## HORSHAM DISTRICT COUNCIL CONSULTATION

| <b>LOCATION:</b>       | Land North of Guildford Road Bucks Green Rudgwick West Sussex                                                                                                                                |
| <b>DESCRIPTION:</b>    | Outline Planning Application for up to 90 no. residential dwellings (including 40% affordable) all matters to be reserved apart from access.                                                 |
| <b>REFERENCE:</b>      | DC/25/1269                                                                                                                                                                                   |

^ Hedgerow lining southern boundary on site, as per Figure 4 in BNG Report.  
v Attenuation create abutting tree RPAs and hedgerow.

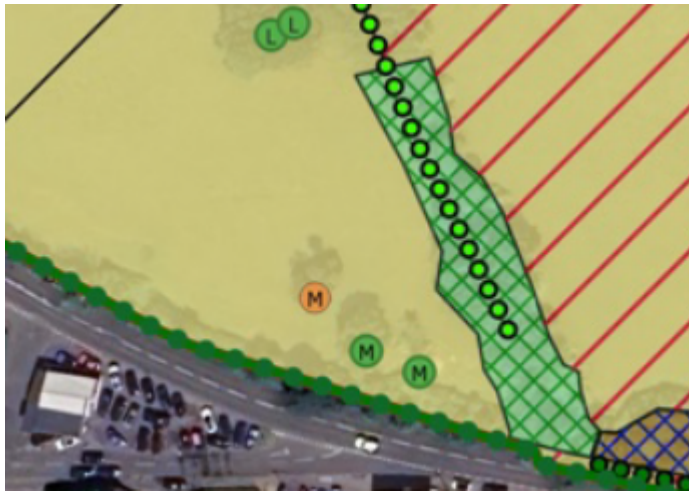
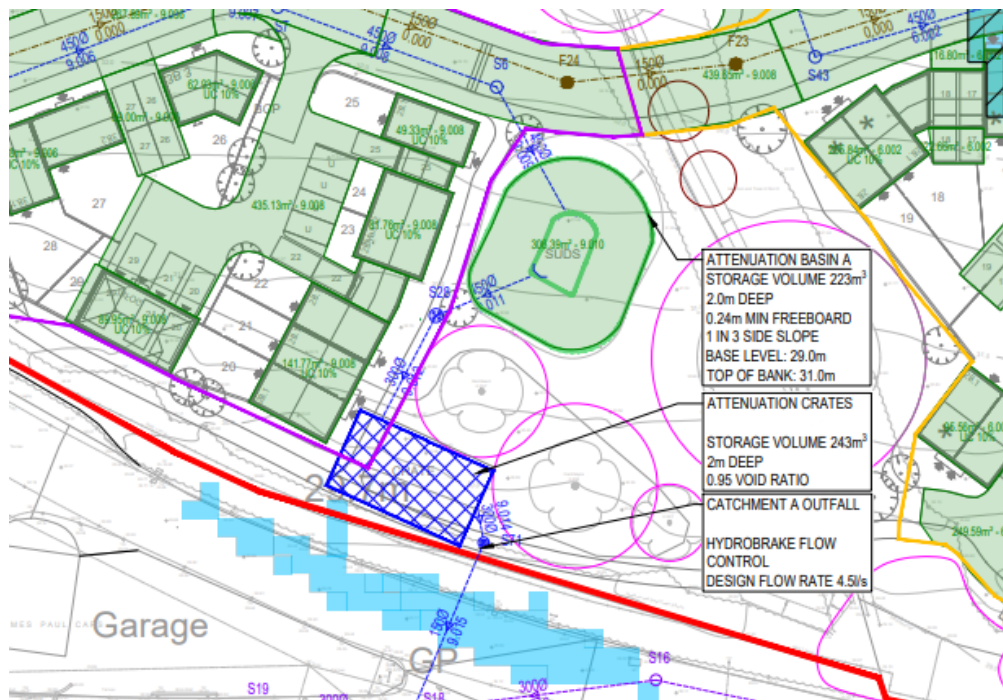
- 2.1 As per the Preliminary Drainage Strategy (Appendix A, Paul Basham Associated Ltd, 2025), an attenuation crate is proposed to be installed in the south of the site and appears to be very close to the retained hedgerow. Please can confirmation be sought as to whether impacts on this hedgerow will be avoided.

*The ecologist refers to attenuation basins, however the original comment refers to the attenuation crate – I have copied two extracts below to illustrate this point. Having discussed with the HDC Arboricultural Officer, it is our view that the installation of the attenuation crate is not possible without hedgerow removal and encroaching on tree root barriers adjacent to the existing tree RPAs. Therefore, this will need amending – it is recommended to relocate the attenuation crates or remove the 2-3 plots to the west of the proposed crate to provide sufficient space for installation. A minimum 1.5m distance is required for installing underground*

crates near hedgerows. Any forecast hedgerow removal will need to be accounted for within the metric.

The agent has confirmed an additional attenuation crate has been inserted in the system 'up stream' of the one located on the boundary. This is located under the car parking area of Unit 28. This has allowed the crate by the boundary to be re-sized so that it keeps 1.5m minimum from the hedgerow. An updated drainage strategy has been submitted to illustrate these changes. The increased 1.5m distance from the hedgerow is welcome. However, the concerns relating to installation of the attenuation crate and encroaching on tree root barriers still stand. Therefore, the retention of this tree remains uncertain.
